FINAL ADDENDUM
TO THE DRAFT EIR

**STATE OF CALIFORNIA
SAN FRANCISCO
CIVIC CENTER COMPLEX
Environmental Impact Report**

SCH No. 94011008

April 21, 1995

Figure 31 (Revised)

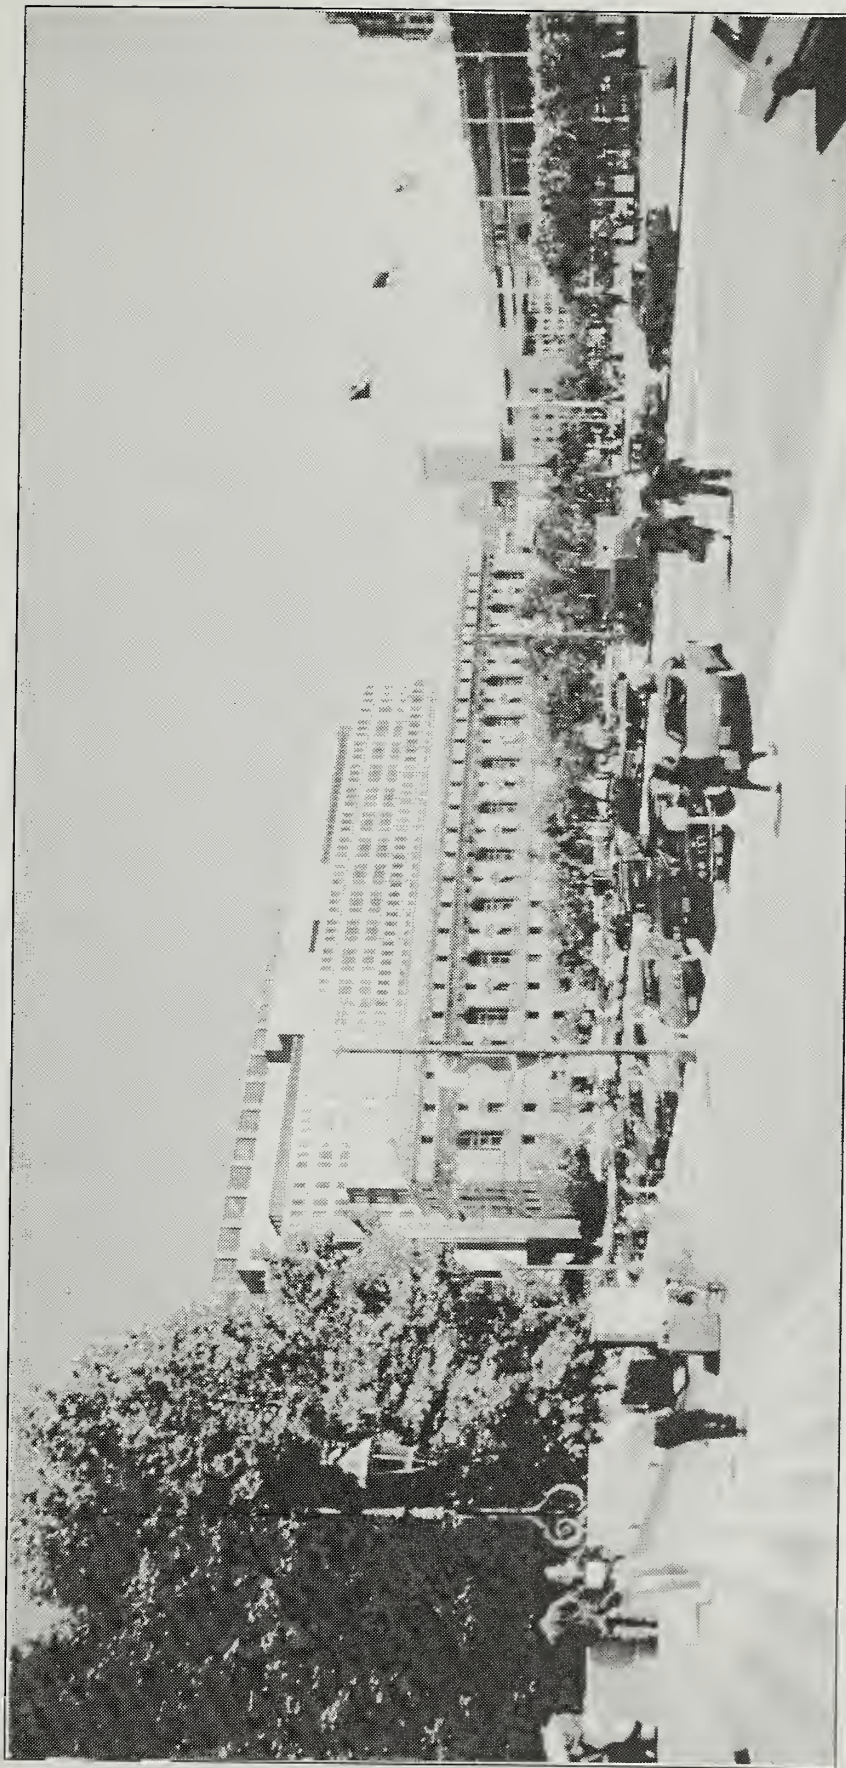
Page 81, Figure 31 is revised to reflect the formal adoption by the City of San Francisco of a local Civic Center Historic District, and to correct minor inaccuracies. The revised Figure 31 appears on p. 26 of this document. [J-1, J-2, J-4, J-5]

- J-2) Please see revised Figure 31 in Chapter II, Revisions to the Draft EIR.
- J-3) The last partial paragraph on p. 83 of the Draft EIR acknowledges that the National Register Districts are on the California Register of Historic Places.

- J-4) Please see revised Figure 31 in Chapter II, Revisions to the Draft EIR.
- J-5) Please see revised Figure 31 in Chapter II, Revisions to the Draft EIR.

- J-1) Subsequent to publication of the Draft EIR in November 1994, the City of San Francisco approved the Civic Center Historic District that was proposed at the time of Draft EIR publication. Please see Chapter II, Revisions to the Draft EIR, where the Draft EIR text on pages S-7, S-14, 80, 83, 85, 89, 101, 111, and 220 has been revised to reflect adoption of the Historic District in December 1994. Please also see revised Figure 31 in Chapter II, which has been updated to reflect the adopted district boundaries and contributory buildings.

Figure 3

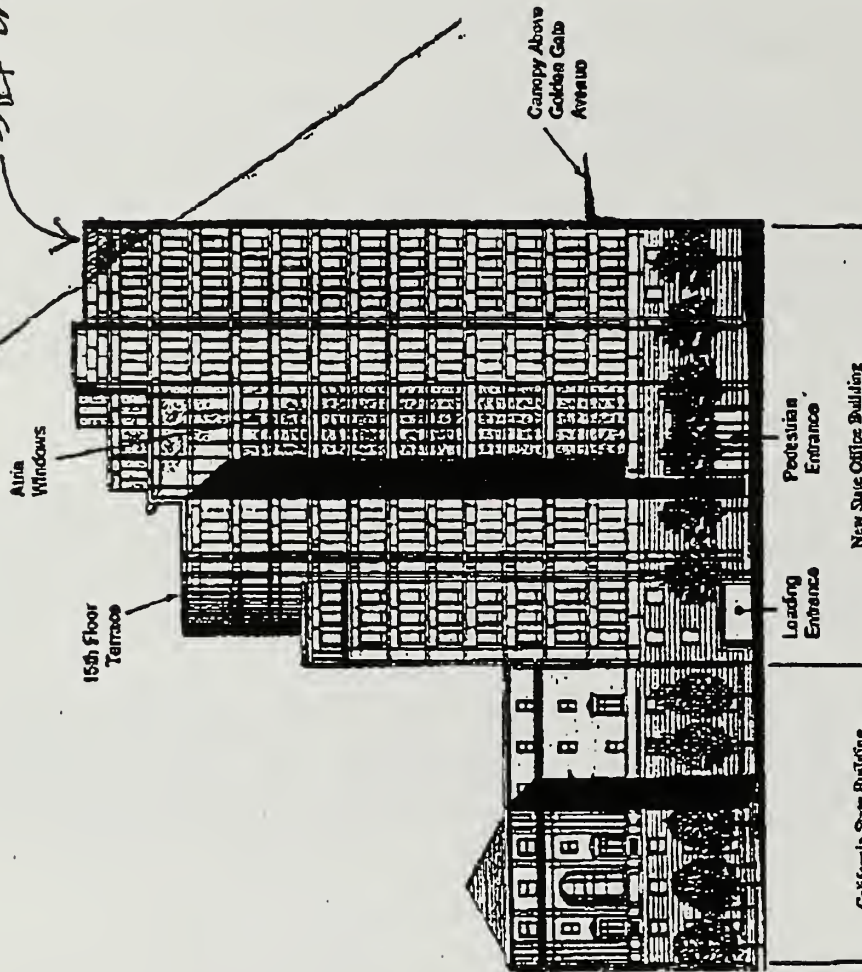
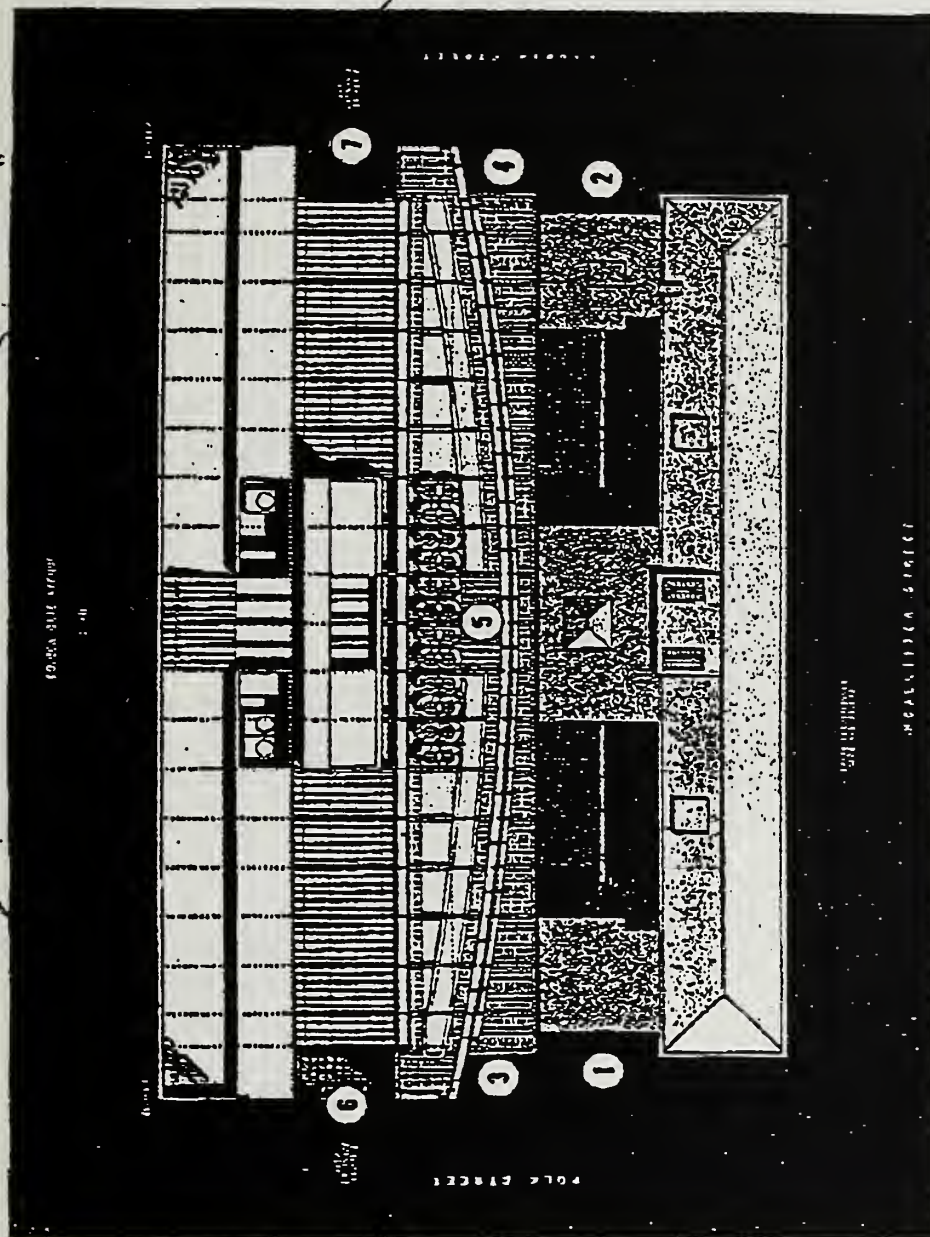
Recommendation: Tapering or stepping back the top few floors on the north facade of the New State Office Building as well as the northeast and northwest corners of the building in plan, as suggested earlier under "Visual Impacts", will decrease by a significant amount the new shading on the Federal Building plaza. (see notes on Figs. 3, 5, 6 and 15 attached)

STEP BACK

Figure 15

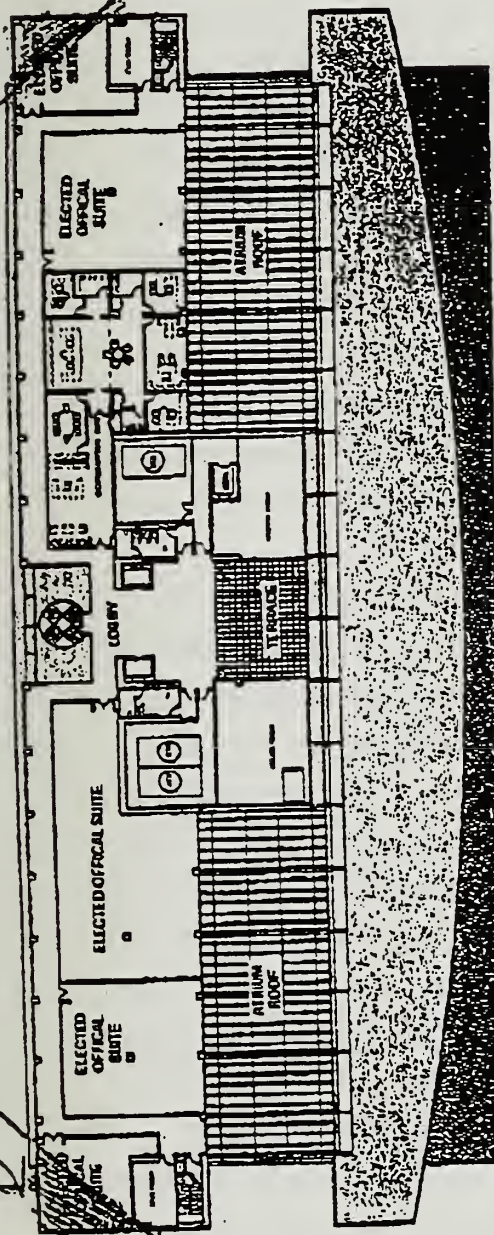
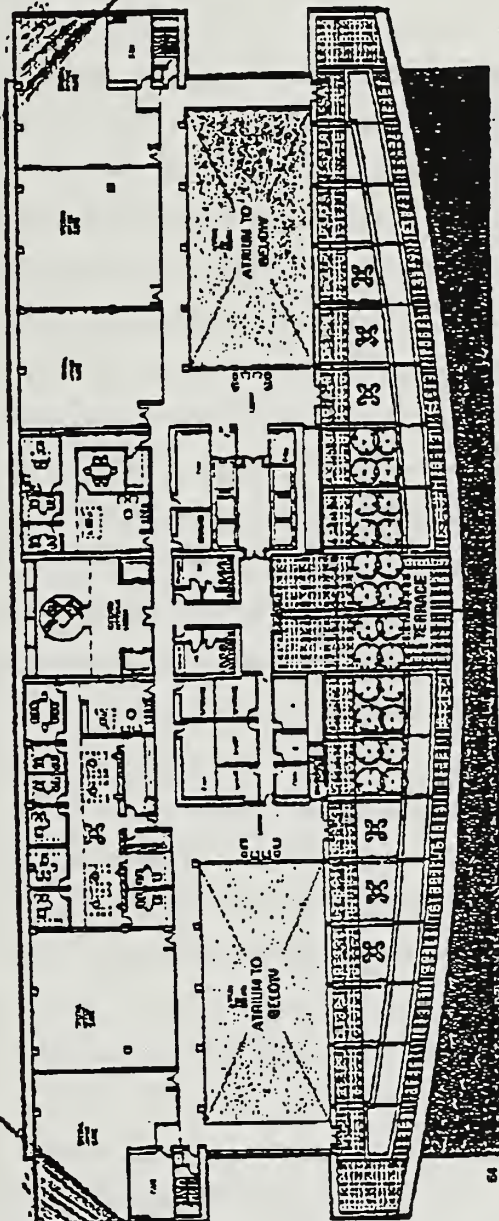
STEP BACK
